STAFF RECOMMENDATION

NCPC File No. 6265

LINCOLN MEMORIAL LINCOLN MEMORIAL CIRCLE SECURITY IMPROVEMENTS, EAST SIDE WASHINGTON, DC

Submission by the National Park Service

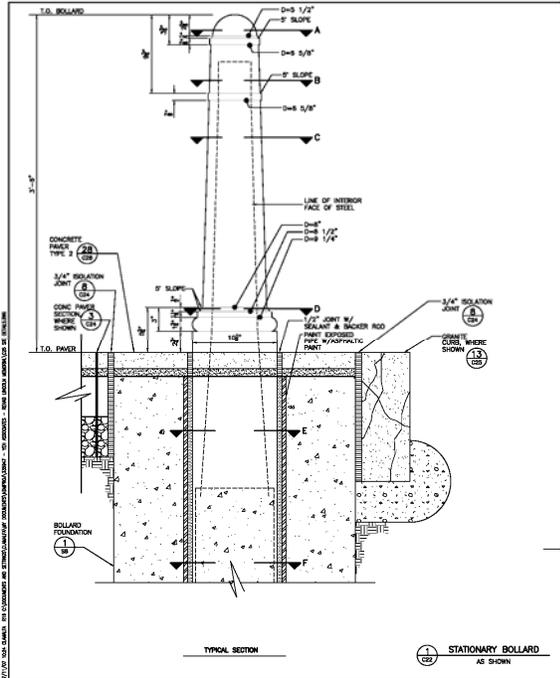
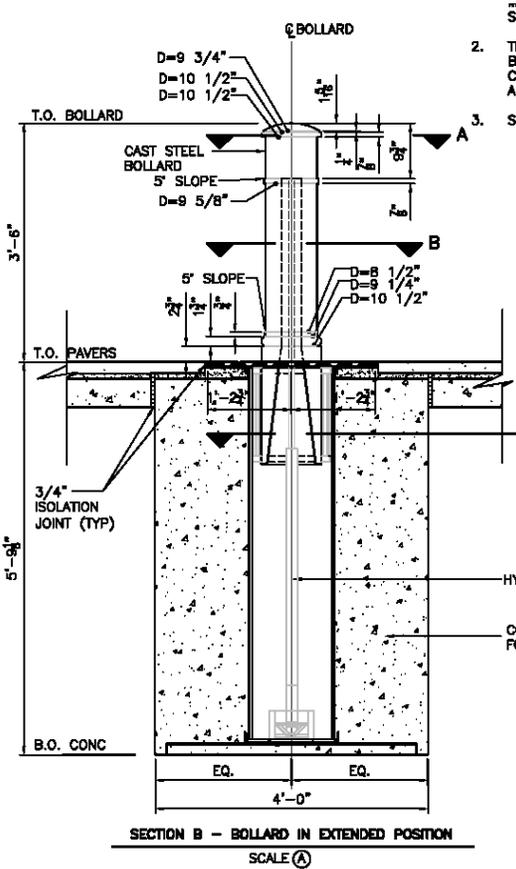
Above, section of the fixed bollard.

Below, section of the retractable bollard.

The steel bollard sleeves will be painted black.

The National Park Service has confirmed with staff that the bollards proposed in the current submission must meet the original security requirements established at the beginning of the project: 42-inch tall bollards (including tapered sides and a cap above the structural core) placed four feet on center. The bollard's classical base is 10 1/2 inches across and the bollard sleeve is 8 inches in diameter at its widest dimension at the base. 250 bollards will be installed. The design of the bollard has been reviewed in the field through the use of samples during several consultation meetings; staff recommends that the Commission approve the design and the color. The steel bollard sleeves will be painted black, as are the segments of post-and-chain around the site. The retractable bollards (a total of six) are of a similar design, but with a different cap profile.

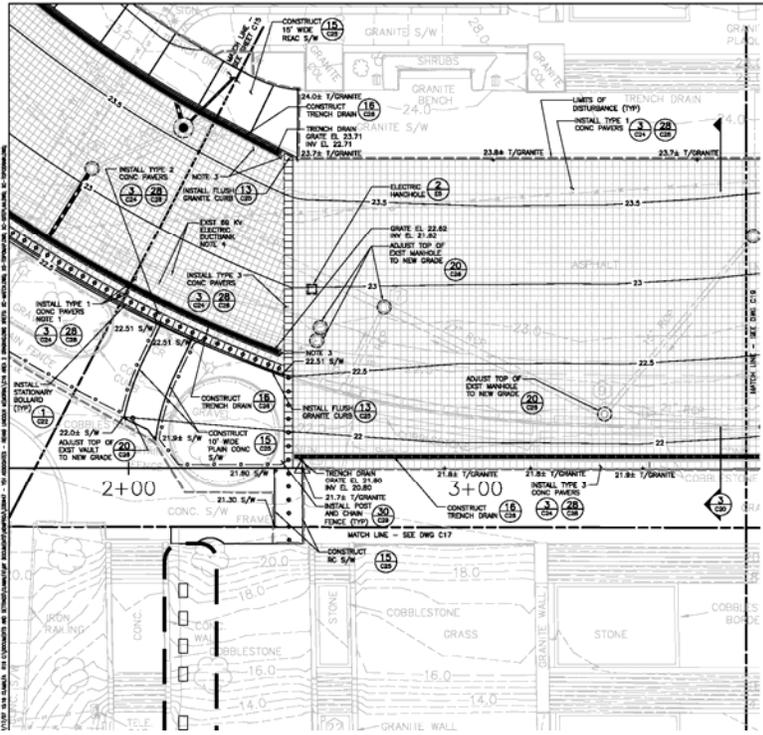
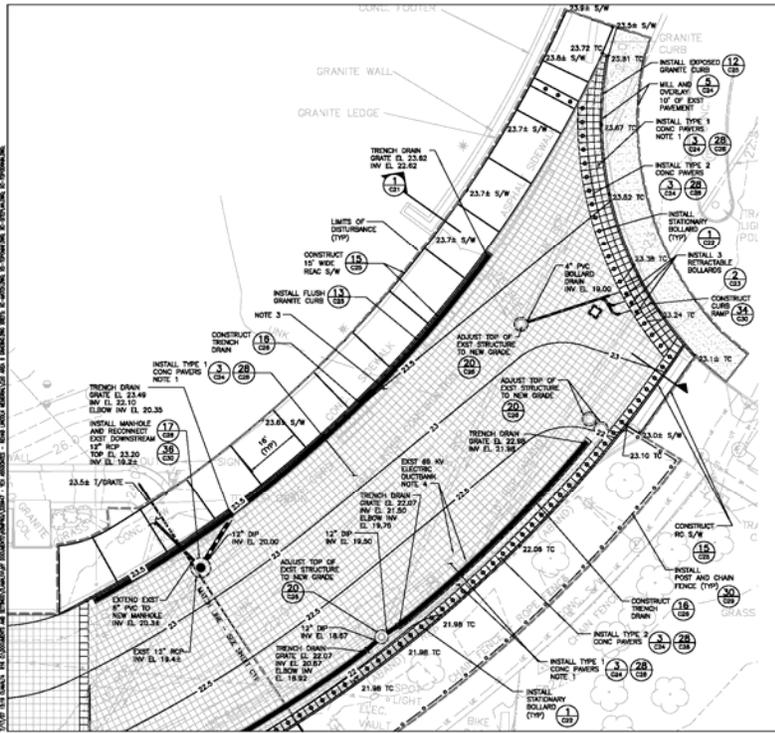
Above, detail of the bollard and pavement plan at the plaza in front of the memorial.

Below, detail of the bollard and pavement plan immediately to the east of Bacon Drive.
